Access Compliance Report Public Rights-of-Way (Pedestrian Signals)

Main Street: **ORANGEWOOD_AVE** Cross Street: **DALE_ST** Location: **NE**

ADA ID: **SGRK210928111448** Signal Type: **One Push Button-Non APS** Overall Compliance: **No** Severity Scores: **BTN 1: 35** **BTN 2: N/A** **No BTN: N/A**

Field Measurements/Component Compliance

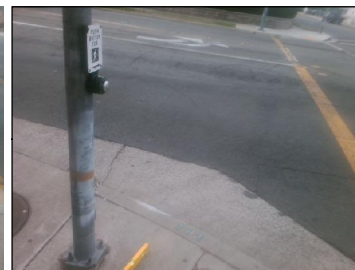
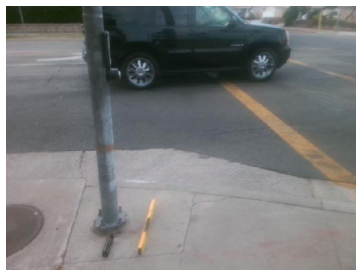
OC Std/PROW: MUTCD 4e.08, R404.2

Possible Solutions: Replace Signal Push Button With APS Button. Remove & Relocate Sign.
